SERVICE LETTER

No. 672

Piper Aircraft Corporation

Wing Rear Spar Inspection

Typ. Rear Spar Attachment

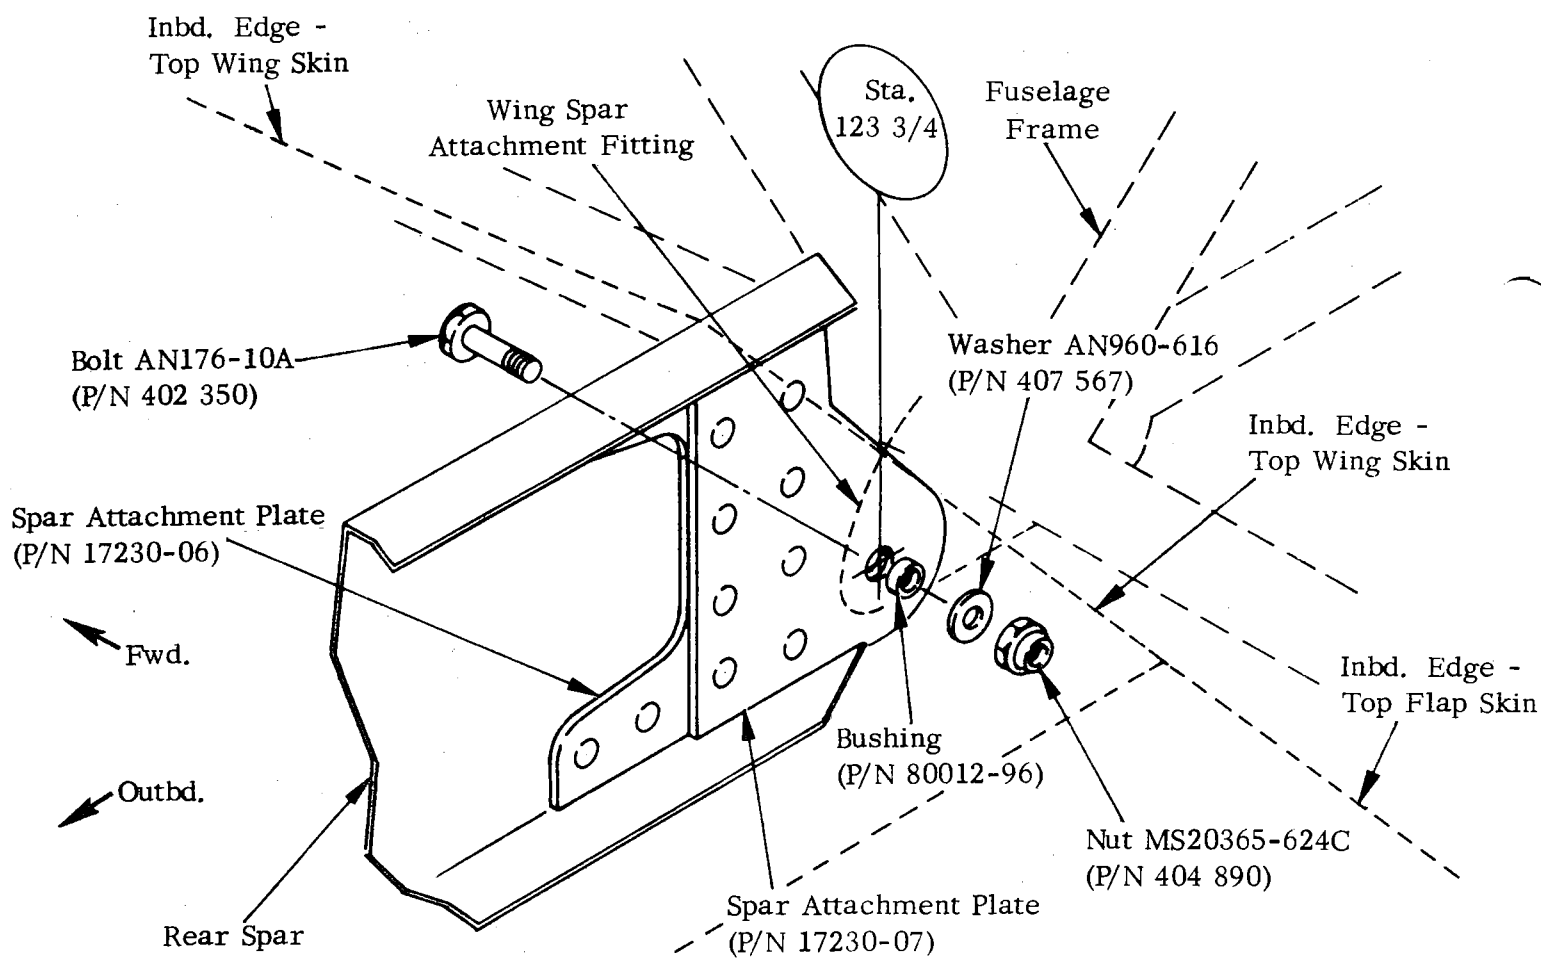
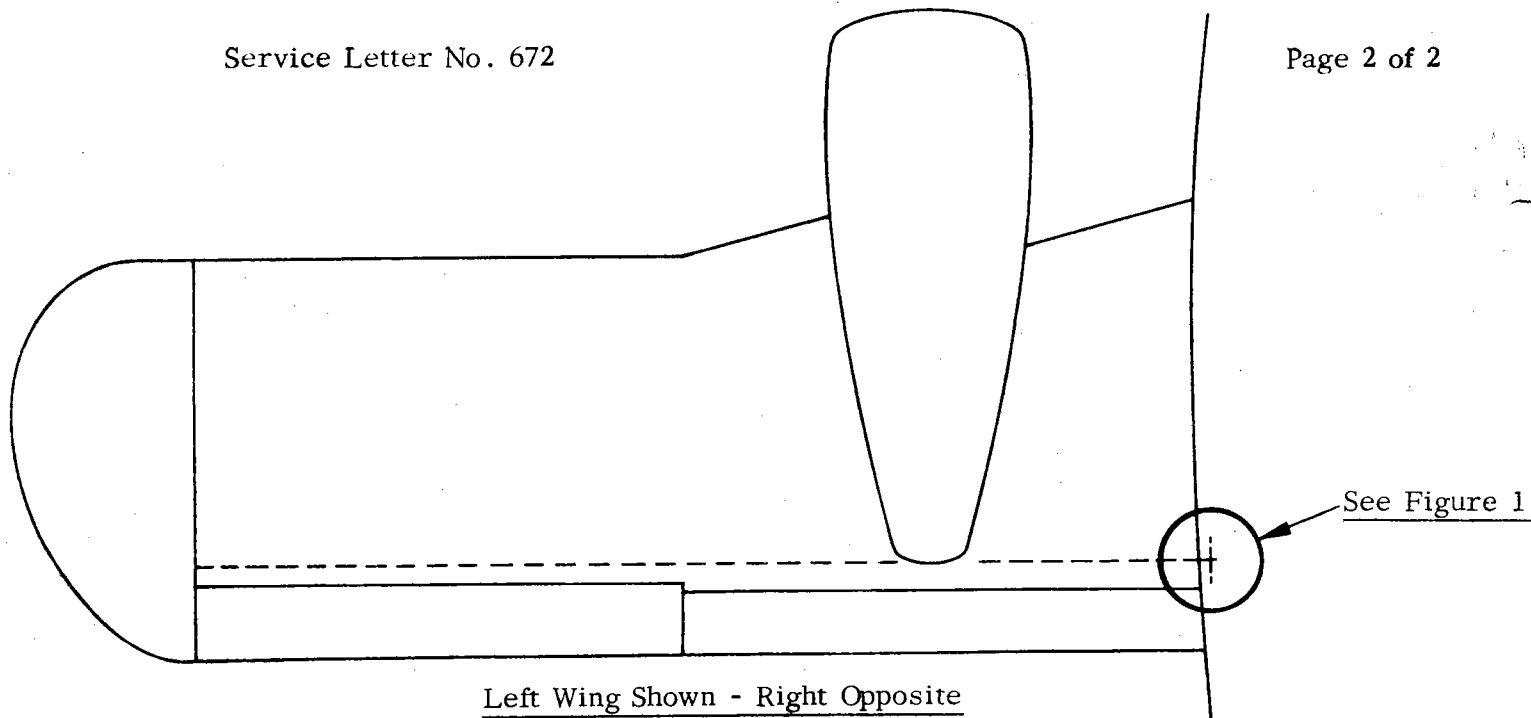
A report has been received by the factory describing wrinkles in the rear inboard wing skin area, occurring on an aircraft with more than 8,000 hours total time in operation. Further examination revealed evidence of wear and cracking in the wing rear spar and rear spar attachment plates.

This service release provides instructions to inspect the rear spar area, rear spar attachment plate and affected attachment hardware for signs of wear and cracks, and to replace worn or damaged parts as required. Refer to sketch/instruction sheet on reverse side for an illustration of the affected area.

1. Inspect rear spar attachment plates and adjacent spar area for signs of wear and/or cracks; also inspect attachment hardware and bushing for signs of wear.
2. If signs of wear and/or cracks are evident, replace parts as required; ascertain that attachment hardware is installed as shown.
